**King's Mark
Environmental
Review
Team
Report**

**STUDIO HILL ROAD
SUBDIVISION
KENT, CONNECTICUT**

Environmental Review Team Report

FEBRUARY 1988

Figure 2

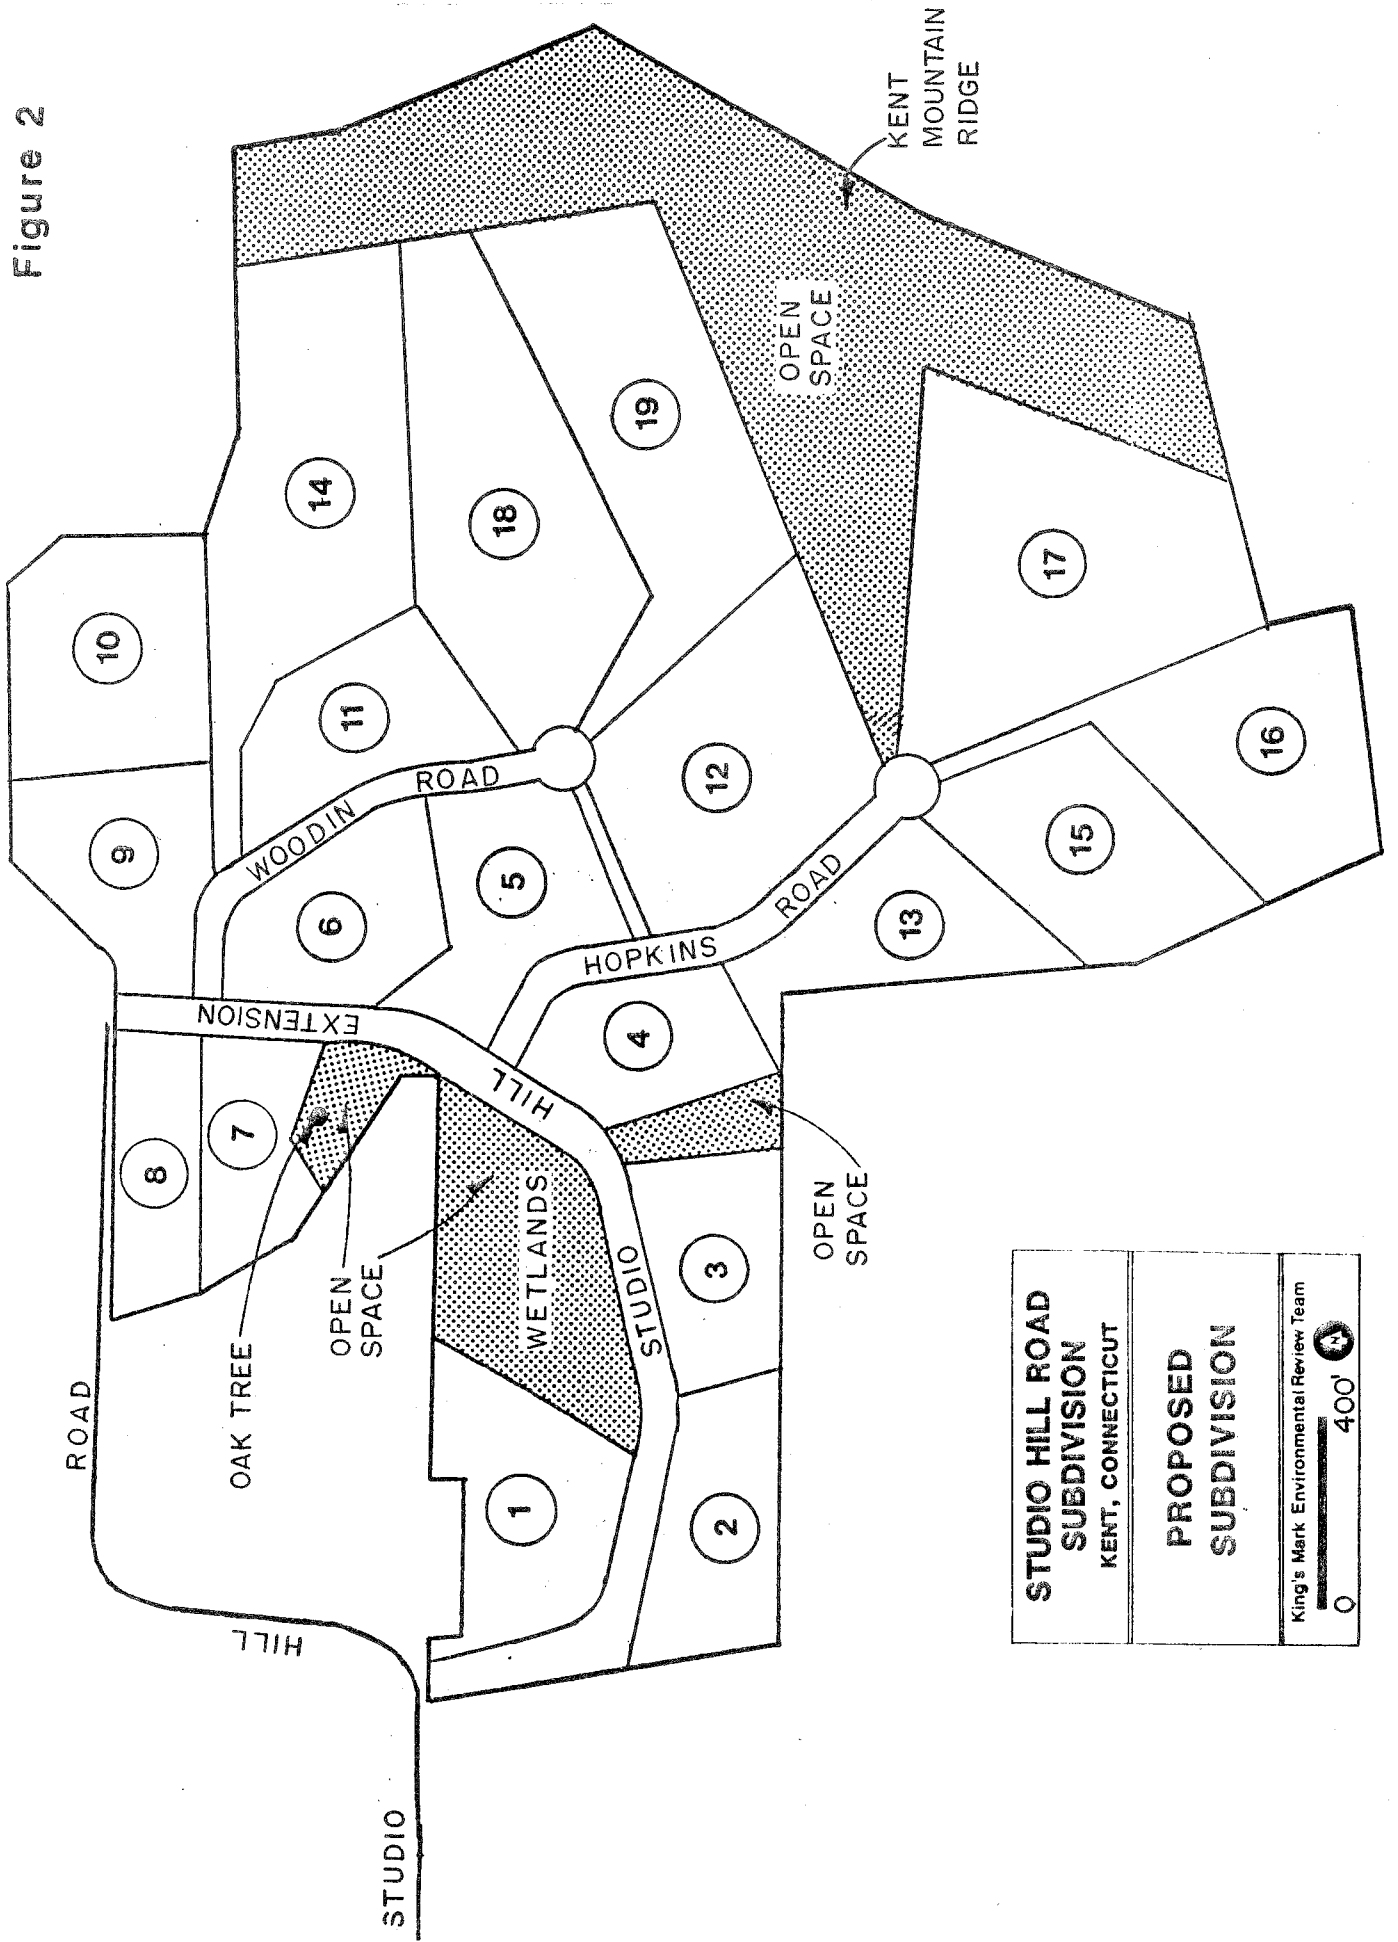
Based on the plans, the subdivision roads will cross several wetland/streamcourses. Wetland crossings are generally feasible, provided they are properly designed. Detailed plans for any proposed crossings should be submitted to the proper town authorities for review. Wetland disturbance can be mitigated by planning and careful delineation of wetland boundaries, using setbacks from the wetlands, and protecting the wetlands with erosion and sediment controls.

All of the wetlands and watercourses should be shown on the site plans. The design of the roads and lots appears to be sound, however this needs to be checked against a complete map. Care should be exercised to avoid unnecessary disturbance to the drainageways on the steep slopes as they provide an important drainage network to the site. The most significant potential impact to the wetlands will be siltation if erosion and sediment controls are not properly developed and maintained.

1. The proposed line of clearing should be shown on the plan or should be clarified. The location of the proposed snow fence (item #2 of the "Sedimentation/Erosion Controls" should be shown on the site plans.

2. The installation and removal of specific E & S controls should be included in the sequence of events. For example silt fence and mulching after final grading are two E & S controls which are typically not installed at the same time.

3. Proposed road cuts and fill should be shown on the same sheet as E & S controls so a comparison can be made between E & S control locations and areas where they are needed. Without this information it is not possible to adequately review the proposed E & S control measures.

4. The vegetation mixes, dates of planting and rates of planting should be included in the plan. Tables 1 and 2 referred to in the "Sedimentation/Erosion Controls" were not submitted for review.

5. The location of all areas to be mulched should be shown on the plan.
6. The location of all watercourses and drainageways should be located on the plans. Without this information it is not possible to adequately plan for septic system location, road culvert and driveway culvert locations, or erosion and sediment controls.

7. The purpose and E & S controls for the berm adjacent to Studio Hill Road Extension is unclear and should be clarified.
8. Table 3 of the "Erosion and Sediment Controls" was not submitted for review. Due to the areas of steeply sloping soil and numerous watercourses on the property, E & S controls are critical to proper site development.

Subdivision plans illustrate a fairly reasonable proposal for house and utility locations on each of the 19 lots. A brief review of this plan did identify the following items which should be reviewed and adjustments made where applicable:

- 1) Plot #1 contains a considerable area of Fredon silt loam, a wetland soil. The existing contours also indicate a relatively flat gradient in the general area of the sewage disposal system further from the wetlands than indicated on the subdivision map. If this is not the case, additional testing should be performed within the proposed primary and reserve leaching areas to determine maximum seasonal groundwater levels and assure both primary and reserve areas are placed not less than 50 feet from the water mark of the brook flowing through this wetlands.

- 2) A major concern with construction on steep slope lots such as exists within this proposed subdivision is the placement of leaching areas above driveways which have been notched out of the hillside. A very real potential for partially treated sewage to bleed out at these soil cuts exists if inadequate separation is provided. The driveway location shown on Lot 4 could be considered a potential problem if a soil cut along the driveway is proposed. Fortunately the gradient is not as severe on this lot as is on the lots to the east. As a general rule, leaching systems located 75 feet upgradient from a soil cut would not be considered a problem.

- 3) The proposed sewage disposal system area serving the residence on Lot 14 appears to be located at the headwaters of a brook. Soil test data obtained from 2 pits adjacent to this septic area identified potential water levels at 24 inches below existing grade. On this 7.7-acre parcel, it is likely that additional tests will be performed to shift the leaching area away from this wet area. The location of the residence further up the hill would obviously provide more flexibility in identifying and selecting a suitable leaching area.

Figure 6

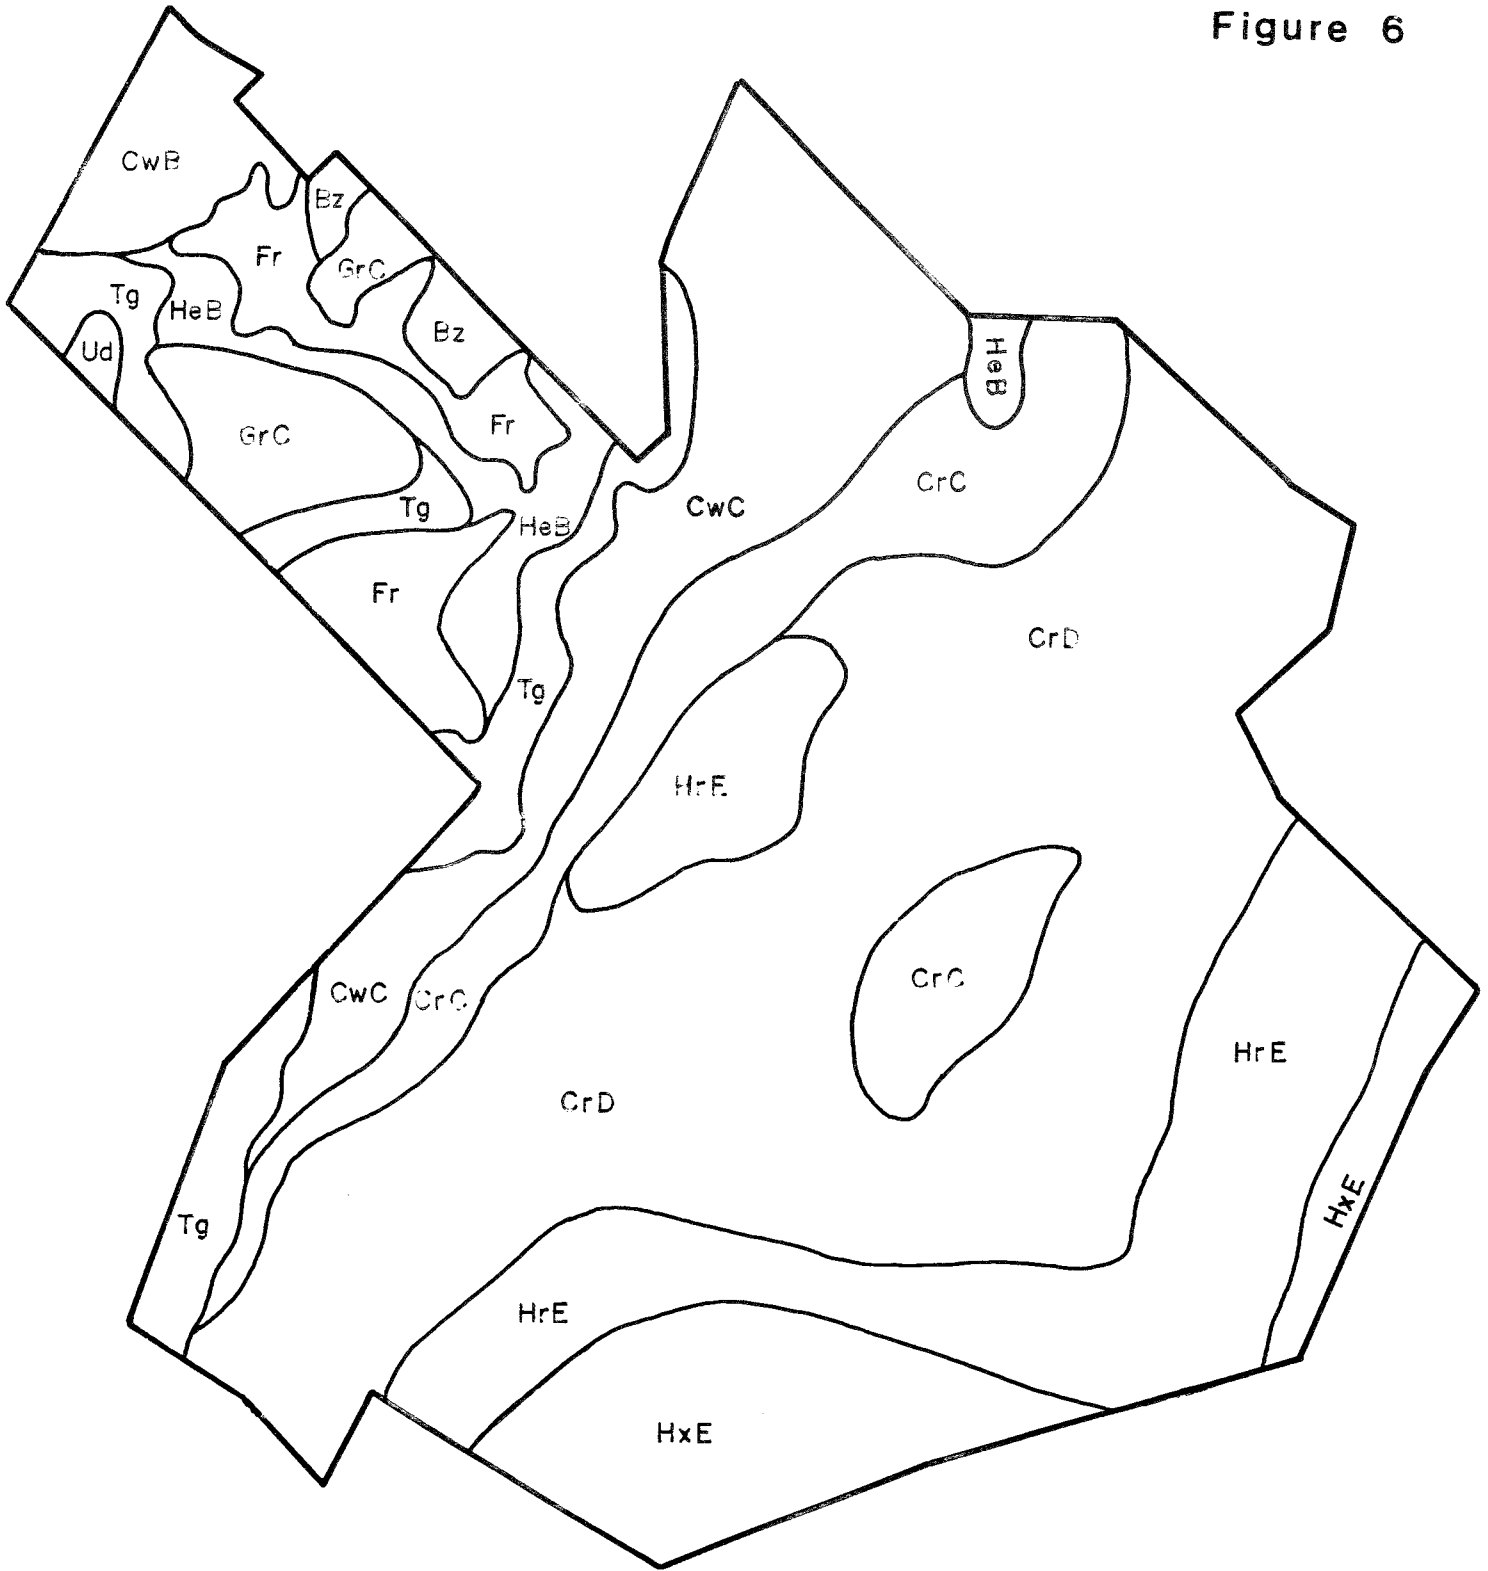
The soil map included in this report (Figure 6) has been created from on-site investigation and information provided during the review (test pit logs, wetland maps, soil maps). This map can be used for a general discussion of soil limitations on the parcel.
